October 10, 2024

**RE: Comments on Application by Barton Mines, LLC
APA Project No. 2021-0245
Ruby Mountain Mine Expansion
Town of Johnsburg, Warren County**

EXHIBIT A

Subject: Barton Mines, LLC
Ruby Mountain Garnet Mine
Major Permit Modification
NYSDEC Mine Permit #5-5230-00002/00002
APA Permit #P79-140, P79-356, P87-39, P87-39A, P87-39B, P88-393, P88-393A
STERLING File #2024-01

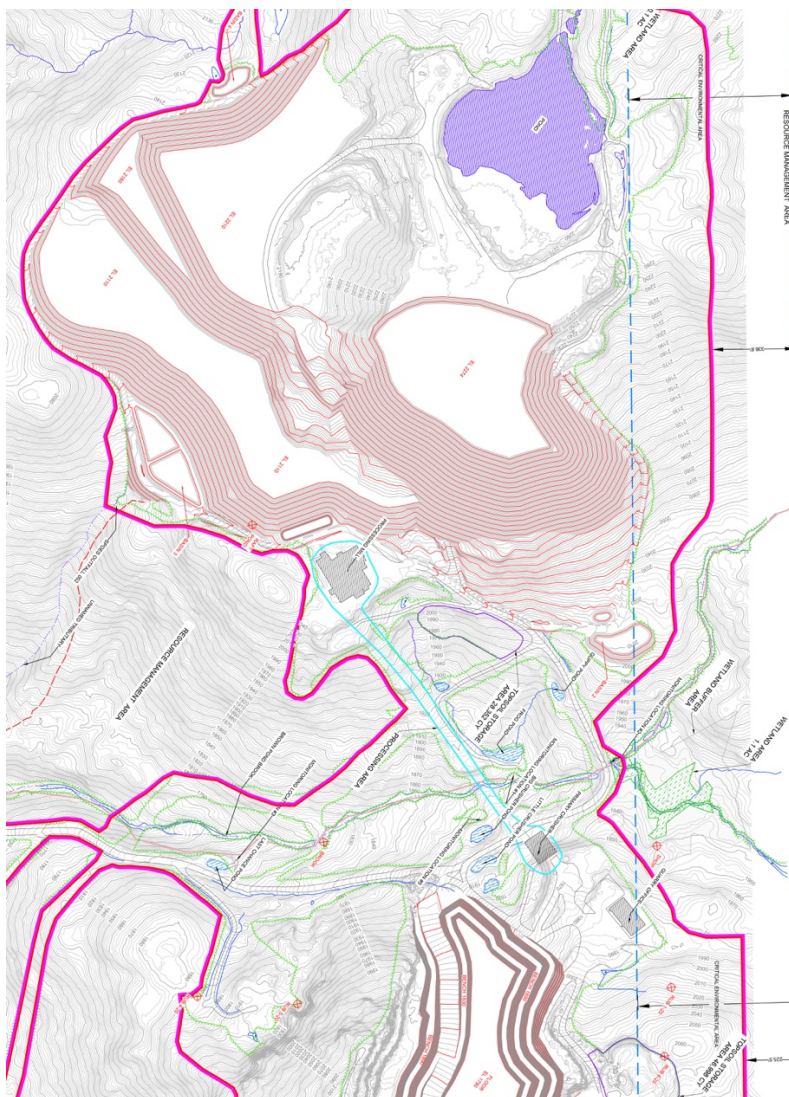
Barton acknowledges that “[t]he proposed expansion will increase permitted activities within the CEA to 29.6 acres, a net increase of 26.1 acres.” Barton Applic. at 44. This proposed expansion of Barton’s industrial activities into the CEA will, by Barton’s own admission, require the destruction of approximately 16,678 trees. *Id.* at 45. Barton proposes to extend both the mining excavation area and the tailings waste pile into the CEA, coming within 225 feet of the boundary line with the Siamese Ponds Wilderness Area. *Id.* (See Figure 3).

As previously acknowledged by APA, the CEA provides a critical buffer between Barton’s industrial mining operations and the Siamese Ponds Wilderness Area. The intrusion of a massive tailings waste pile and open pit mining into the CEA would obliterate a large portion, approximately 36%, of the CEA on that side of the mine and severely limit its effectiveness as a buffer. This is fundamentally at odds with the purpose of its statutory designation as a CEA and will therefore have an undue adverse impact on Adirondack Park resources. APA should not permit any further expansion of the mine into the Siamese Ponds Wilderness CEA.

Figure 4. Aerial view showing the mine in proximity to the Siamese Ponds Wilderness Area and Thirteenth Lake. Base map from APA website.

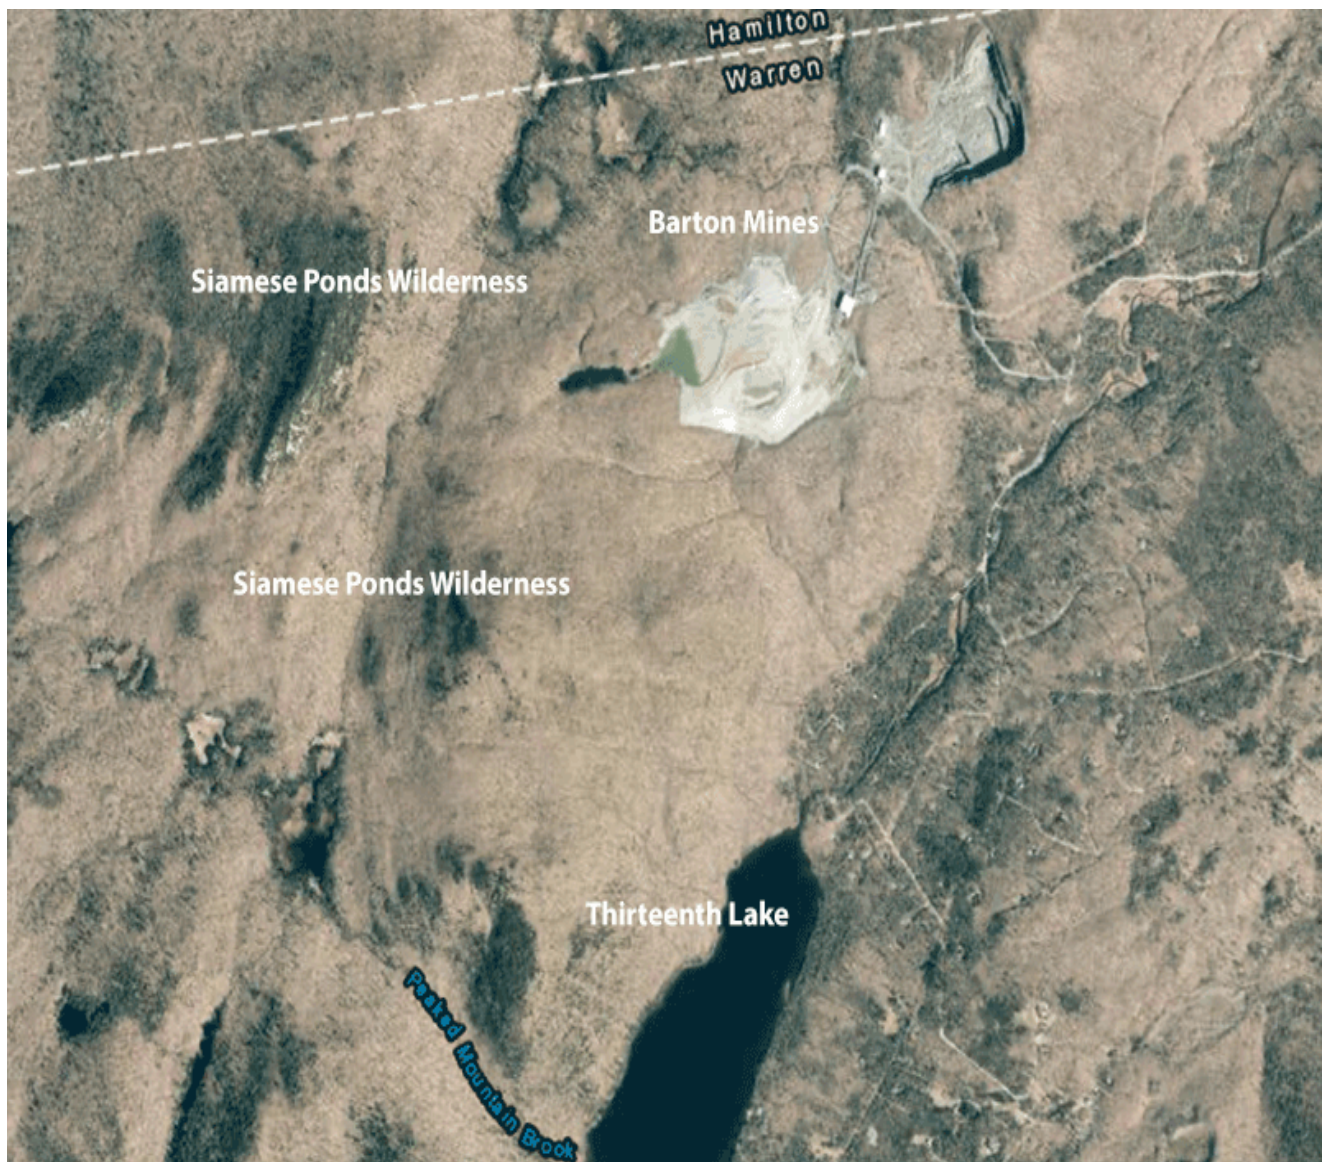
The Sterling report makes clear that Barton's conclusion that the tailings waste pile is stable and will not fail during the proposed expansion is unsupported by reliable data and is at odds with good engineering practice. Given the uncertainty regarding the current stability of the waste pile, the proposal to significantly expand it laterally and vertically risks catastrophic failure and will therefore have an undue adverse impact on the natural resources of the Adirondack Park and poses a risk to the safety of the public. (*See* Figure 4).
